**CITY OF TEMPE
DEVELOPMENT REVIEW COMMISSION**

**Meeting Date: 06/11/2019
Agenda Item: 4**

ACTION: Request a Development Plan Review for a new 2,318 square foot restaurant with a drive through for CHIPOTLE STORE #3457, located at 1655 West Elliot Road. The applicant is SBL Engineering LLC. (PL190071)

Planting Plan

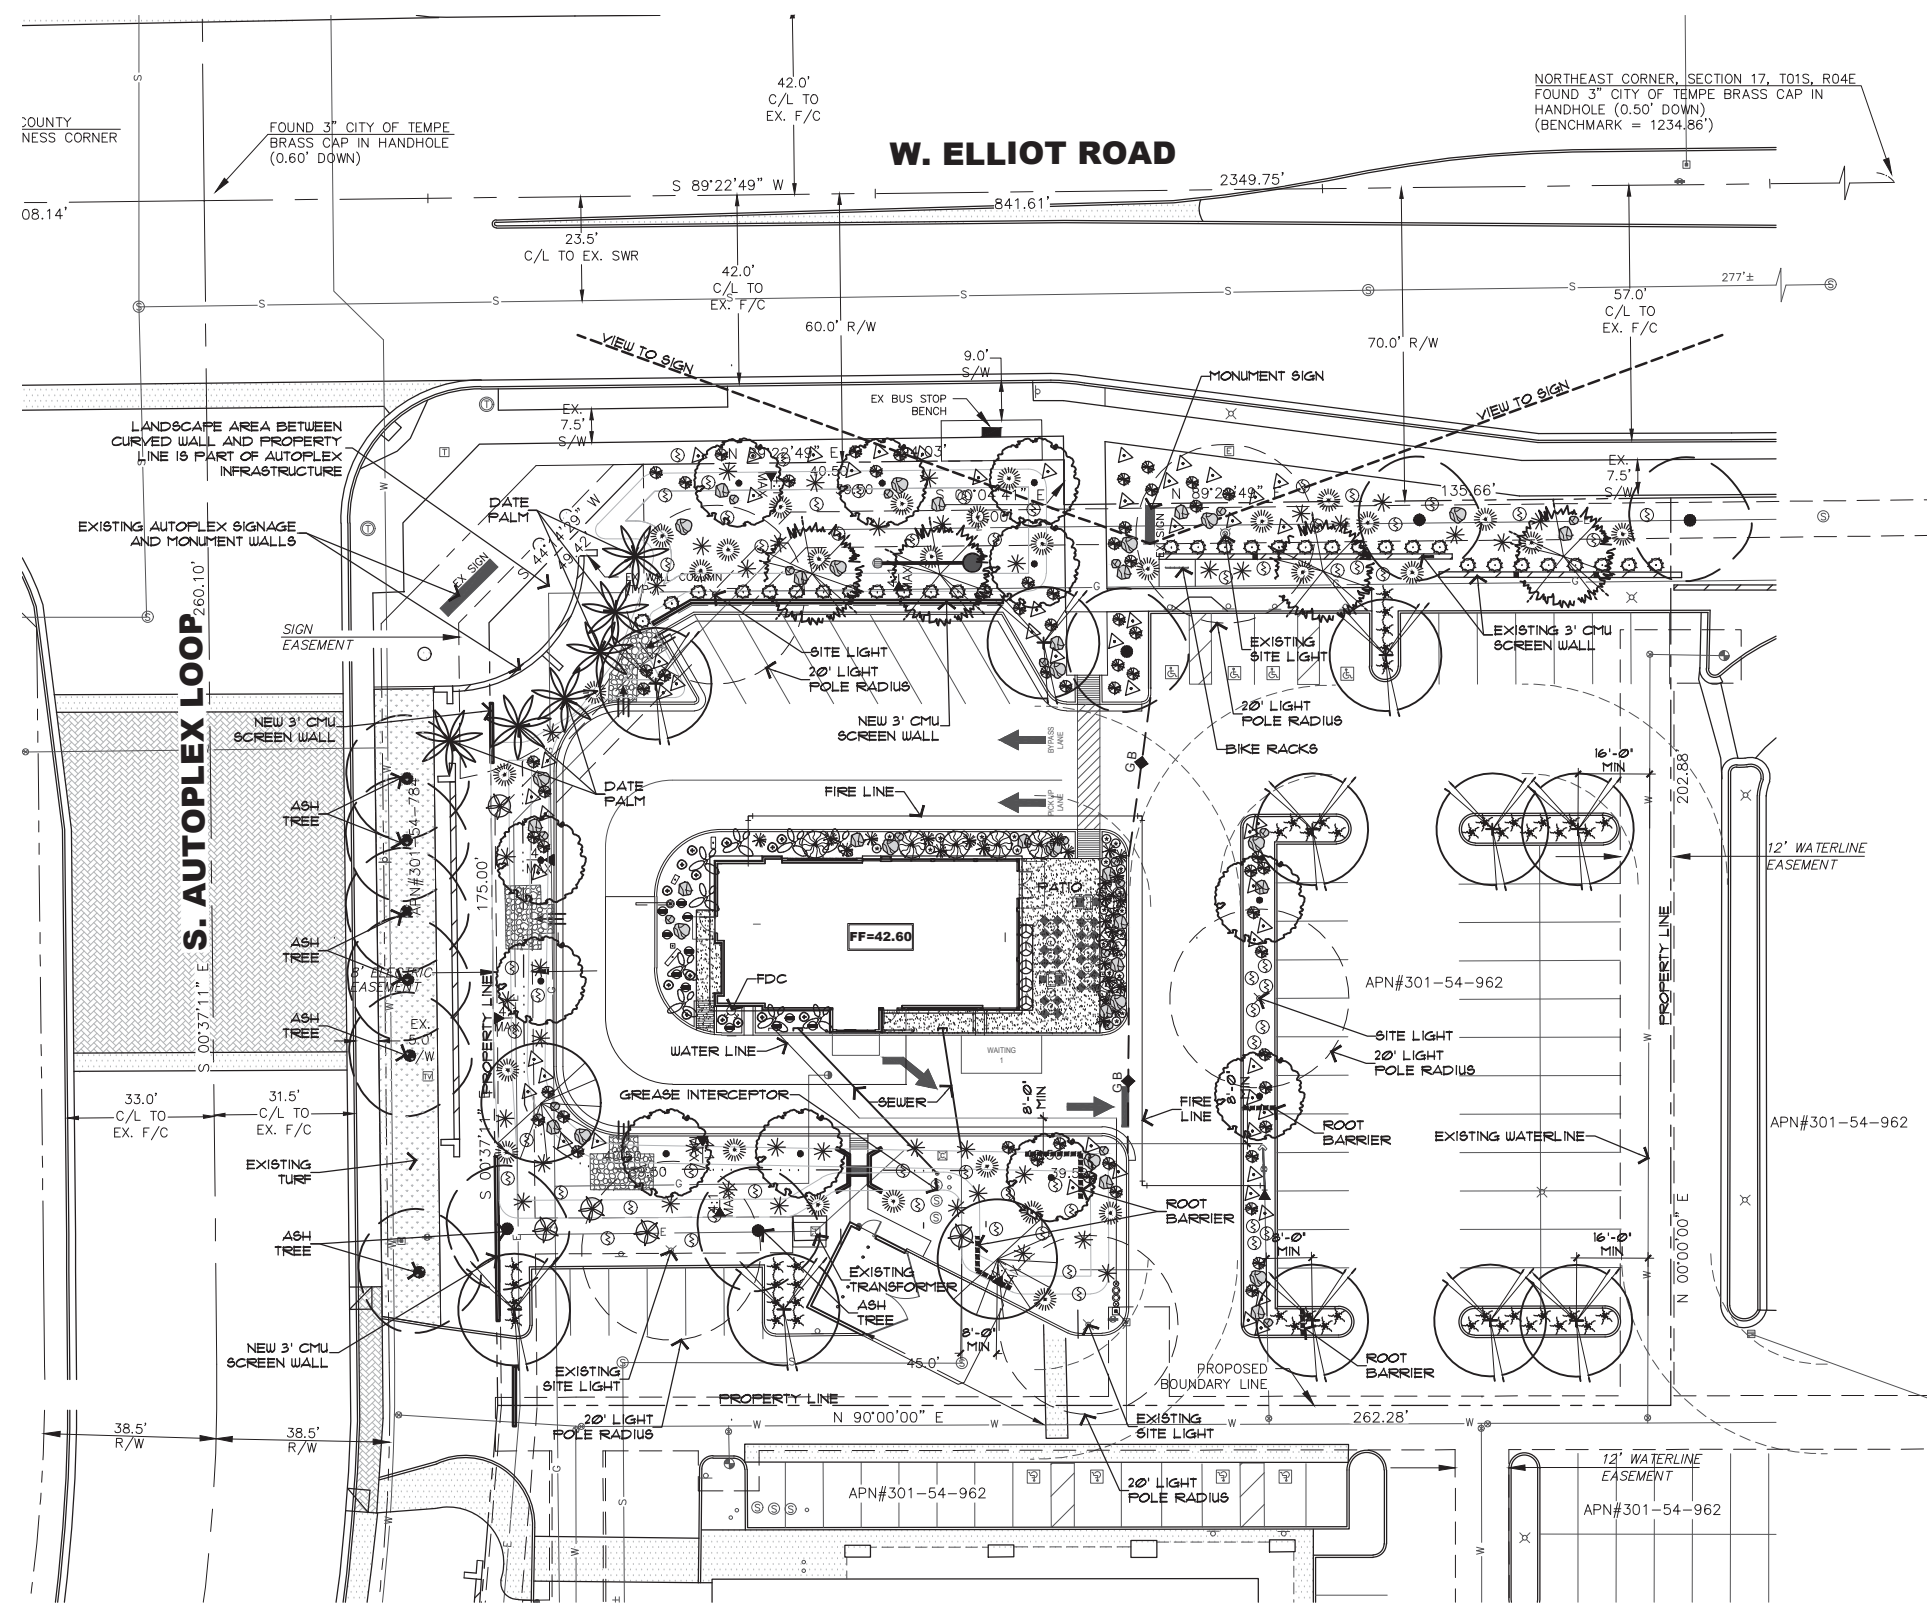
7. Staff commented to bring all landscape islands into conformance with Section 4-704; *this comment was addressed on the revised plans.*
8. Staff recommended replacing Mexican Bird of Paradise with 'Fan West' Ash along the drive-through lane; *the applicant provided one ash tree along the drive-through lane.*
9. Staff recommended replacing Mexican Bird of Paradise with Evergreen Elm along the street frontage on West Elliot Road; *these comments were not addressed on the revised landscape plan and will be required to comply by condition of approval (Condition of Approval #14).*

13. Arterial street trees shall be a minimum of 36" box specimens and a minimum of 1 ½" caliper trunk.
14. **Replace Mexican Bird of Paradise with Evergreen Elm on the street frontage along West Elliot Road.**
15. Irrigation notes:
 - a. Provide pipe distribution system of buried rigid (polyvinylchloride), not flexible (polyethylene). Use of schedule 40
